# Accessibility Review

## Assessment report

The proposal comprises the construction of the new Chau Chak Wing Museum in the north eastern sector of the Camperdown campus. The proposed museum will comprise a new five level building (maximum of three storeys above ground) with central void and will include:

Project Title  
**UNIVERSITY OF SYDNEY**  
**CHAU CHAK WING MUSEUM**

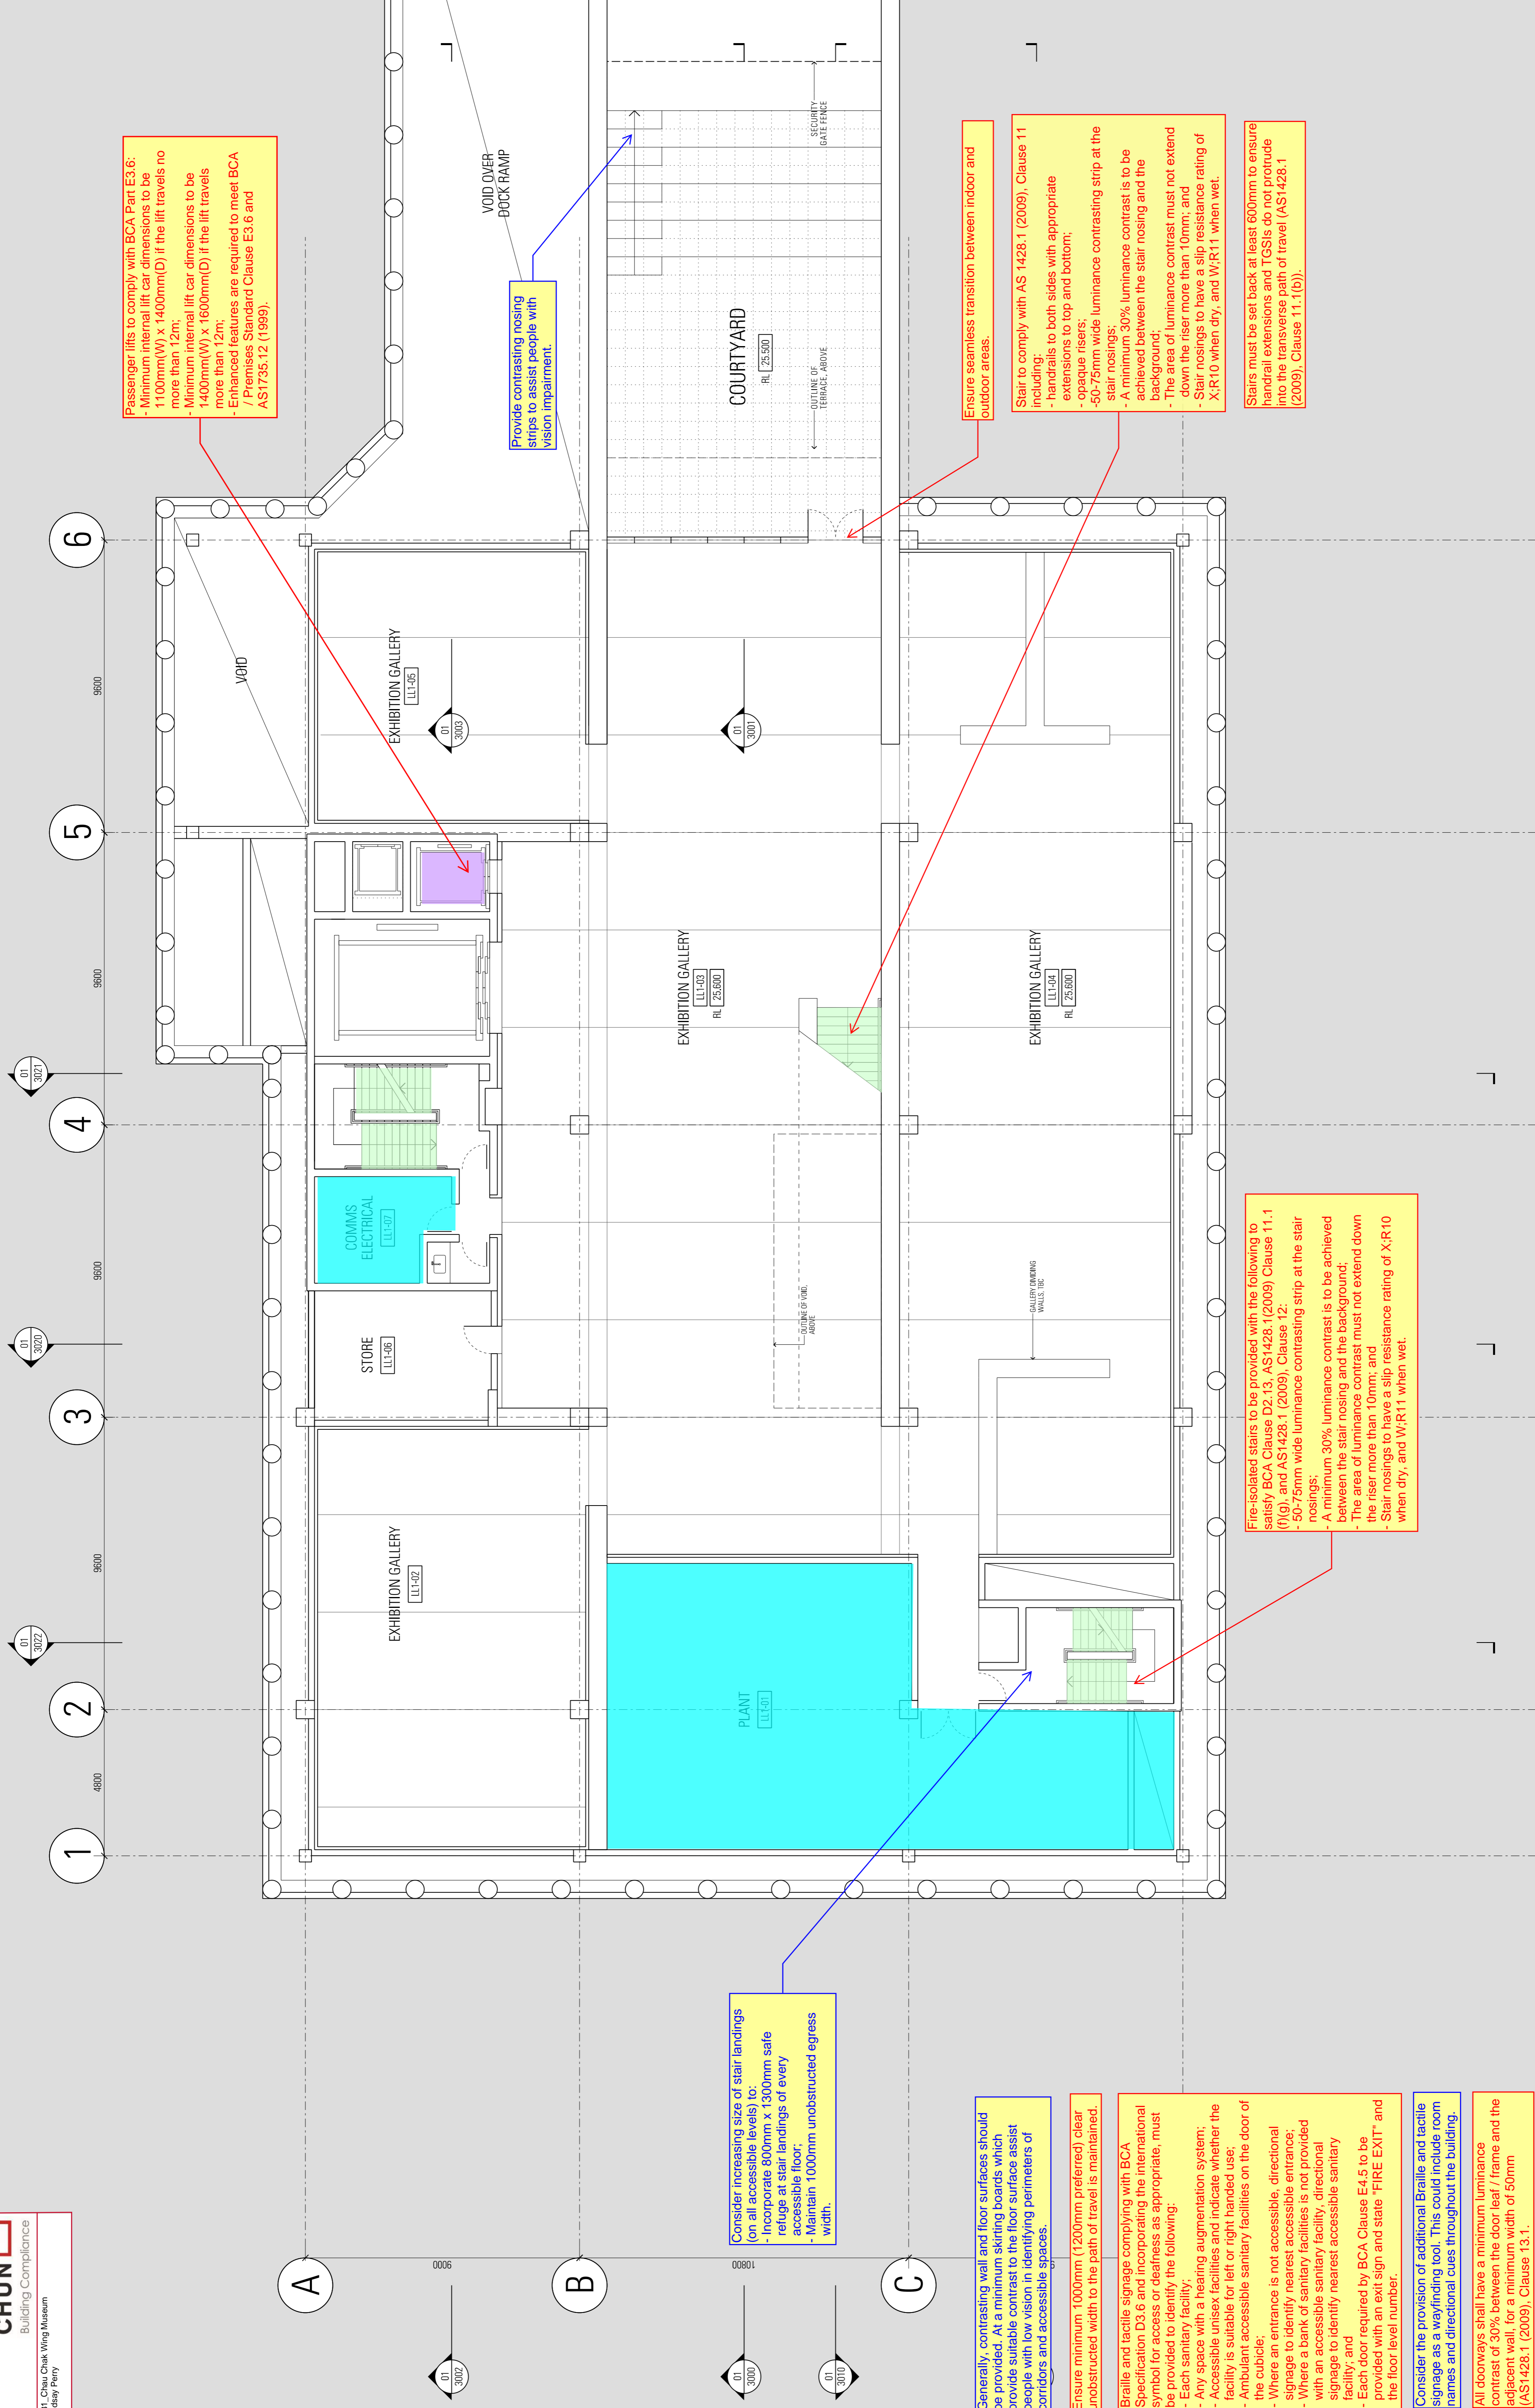
Stair to offer compliance with S1428.1 (2009) unless it offers access to an area deemed exempt under BCA Clause D3.4.

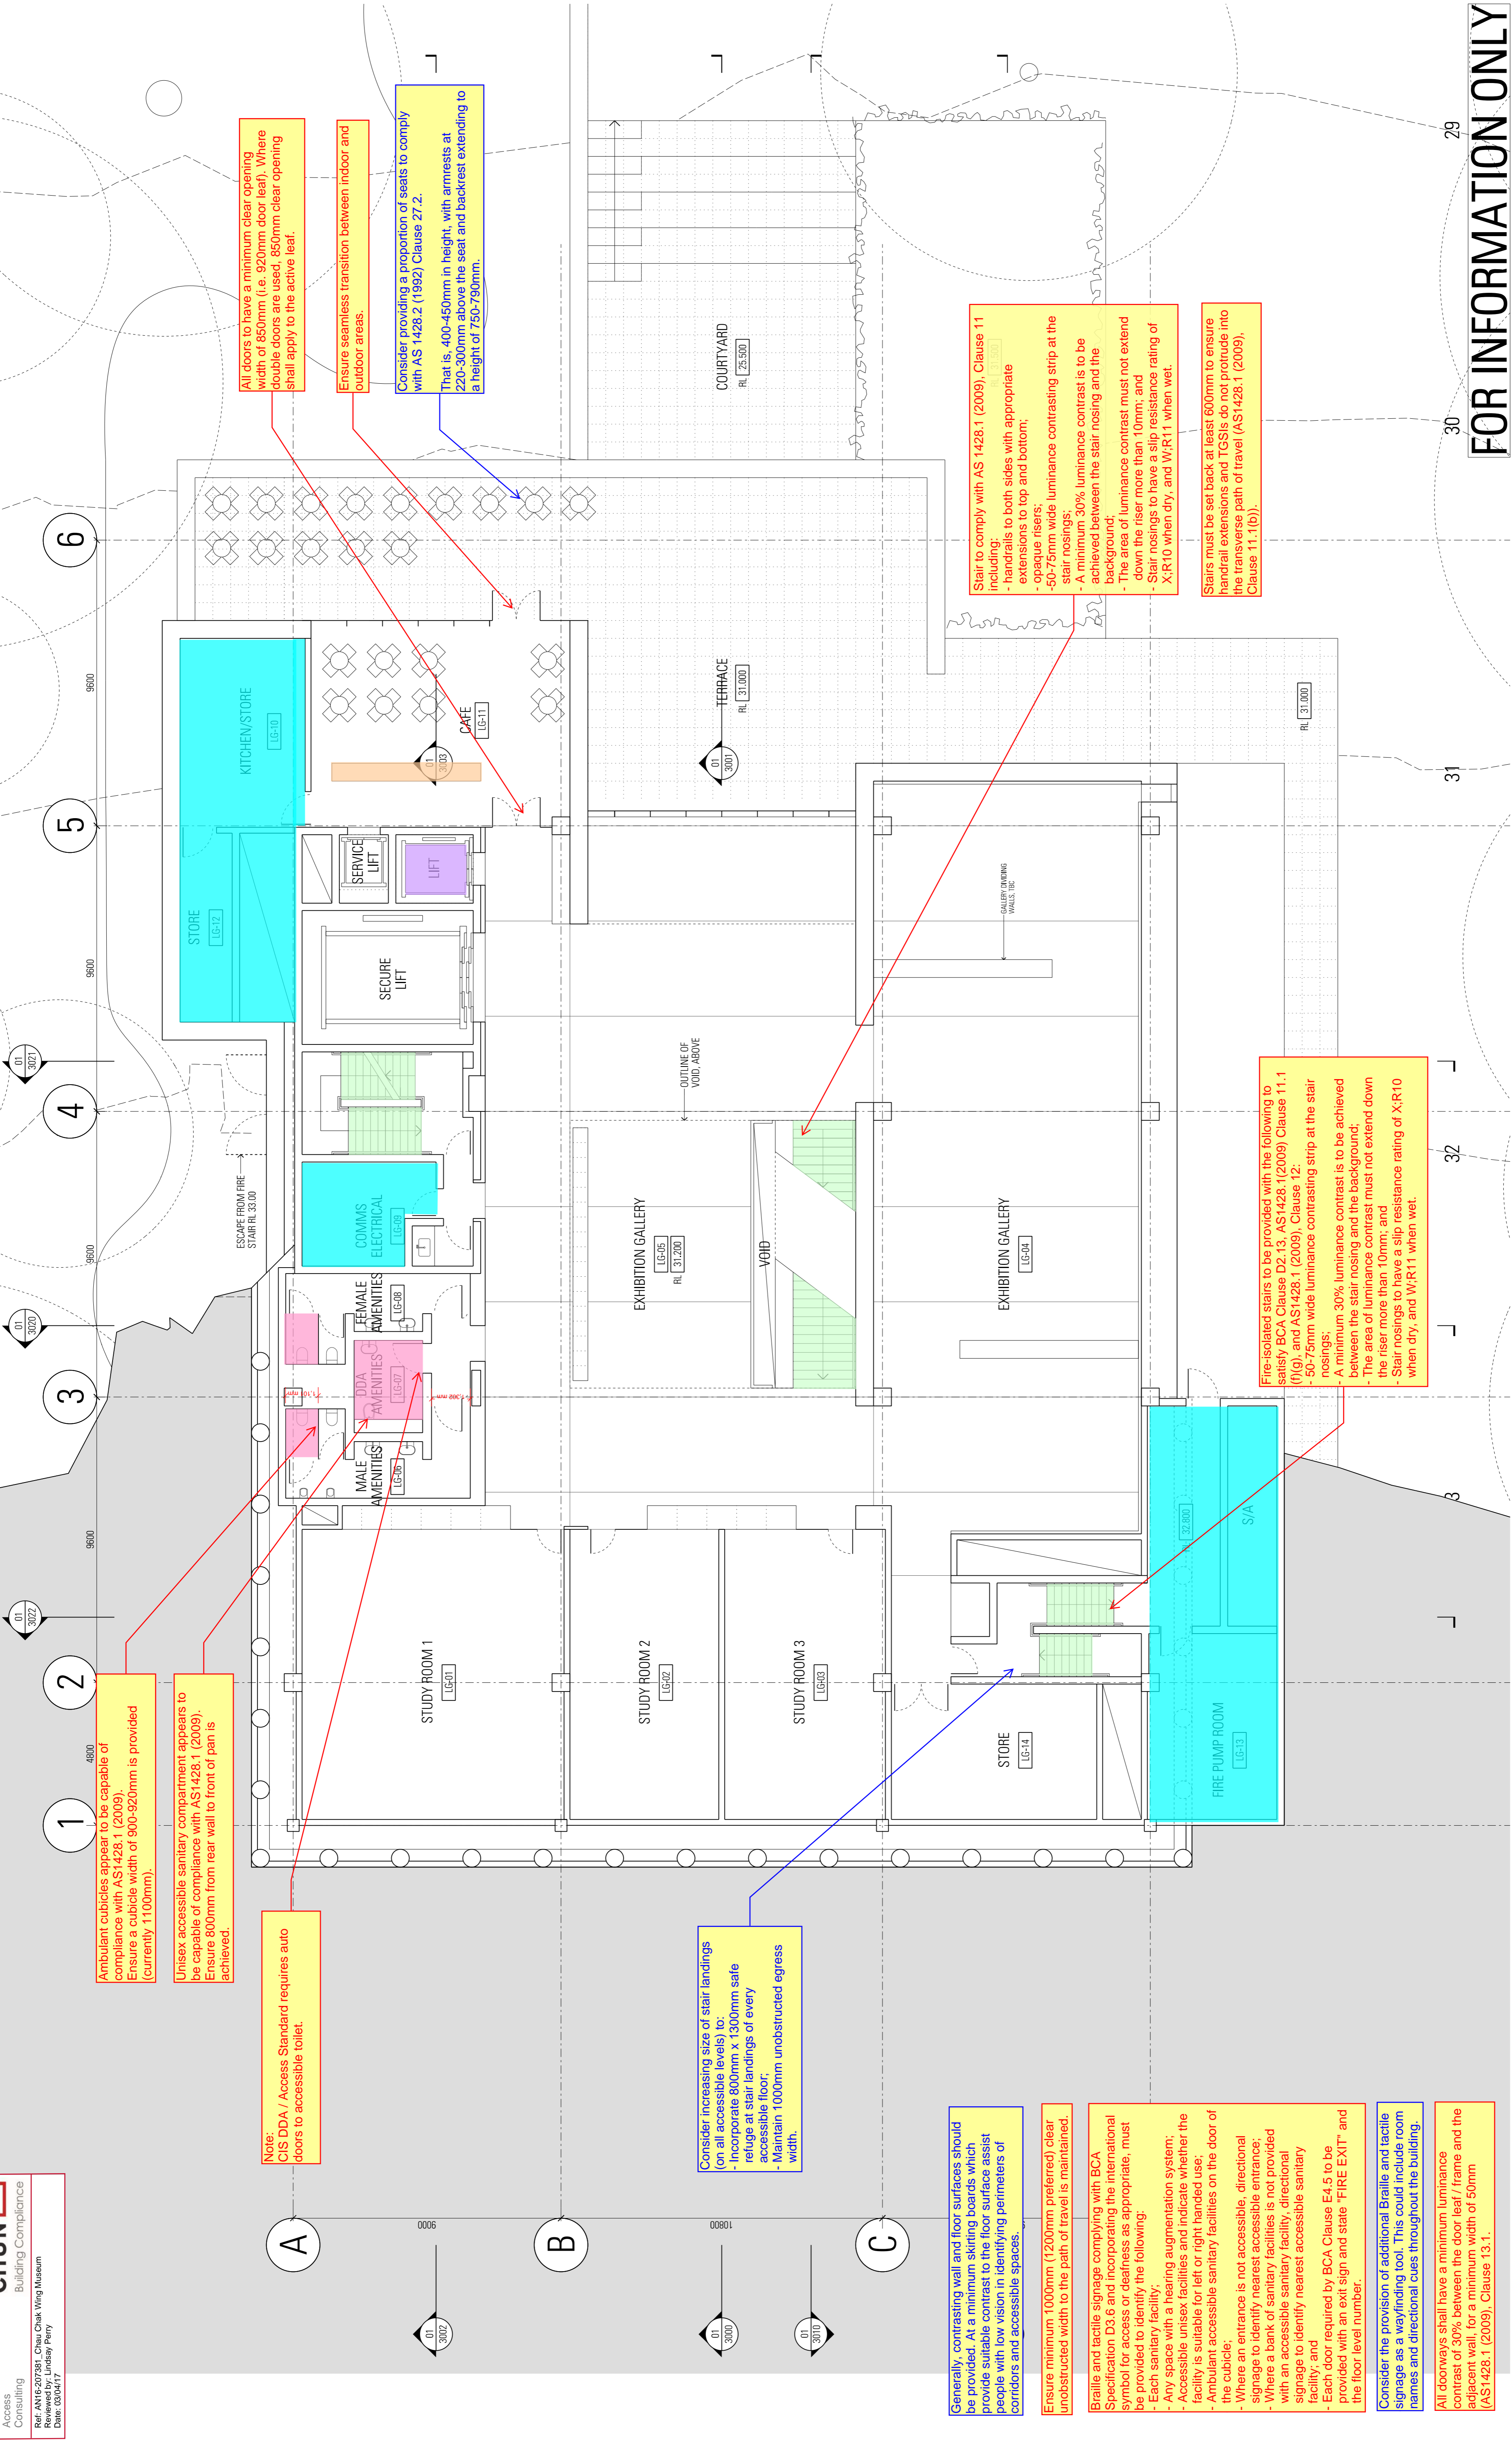
Provide contrasting nosing strips to assist people with vision impairment.

Fire-isolated stairs to be provided with the following to satisfy BCA Clause D2.13, AS1428.1(2009) Clause 11.1 (f)(g), and AS1428.1 (2009), Clause 12:  
 - 50-75mm wide luminance contrasting strip at the stair nosings;  
 - A minimum 30% luminance contrast is to be achieved between the stair nosing and the background;  
 - The area of luminance contrast must not extend down the riser more than 10mm; and  
 - Stair nosings to have a slip resistance rating of X:R10 when dry, and W:R11 when wet.

Consider increasing size of stair landings (on all accessible levels) to:  
 - Incorporate 800mm x 1300mm safe refuge at stair landings of every accessible floor;  
 - Maintain 1000mm unobstructed egress width.

**Drawing Number**  
JPW-SD-A-1005

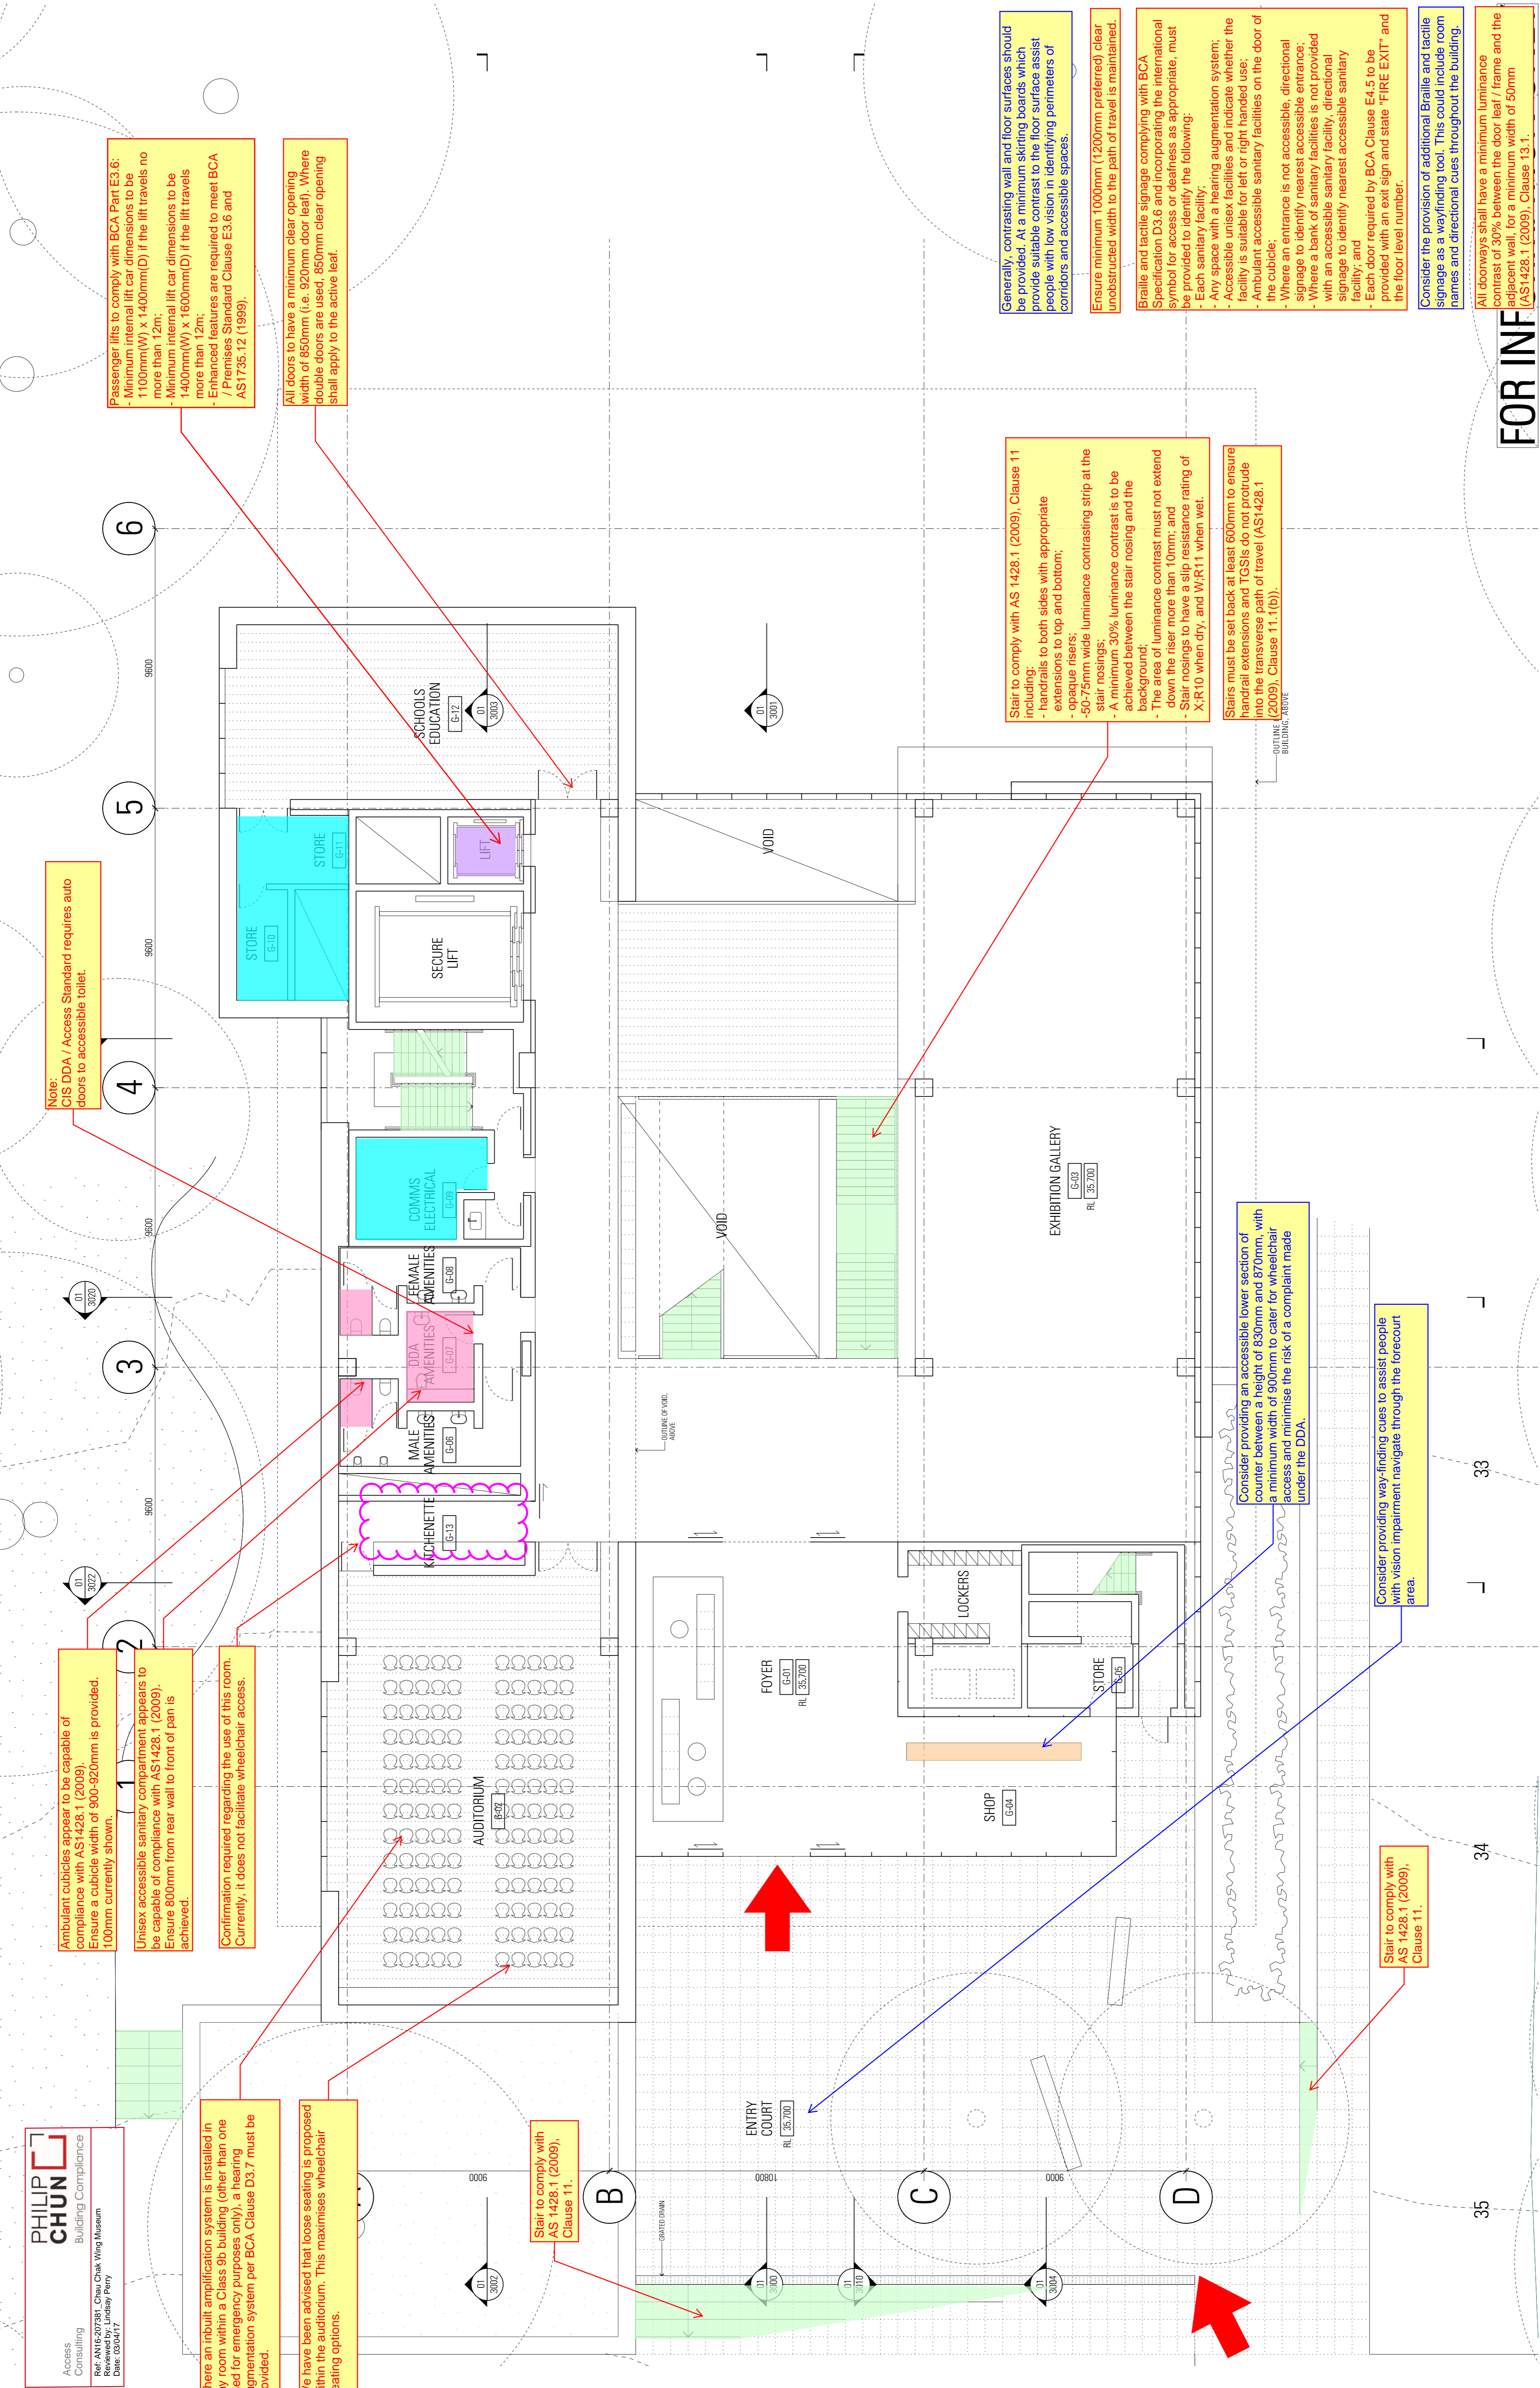
Generally, contrasting wall and floor surfaces should be provided. At a minimum skirting boards which provide suitable contrast to the floor surface assist people with low vision in identifying perimeters of corridors and accessible spaces.
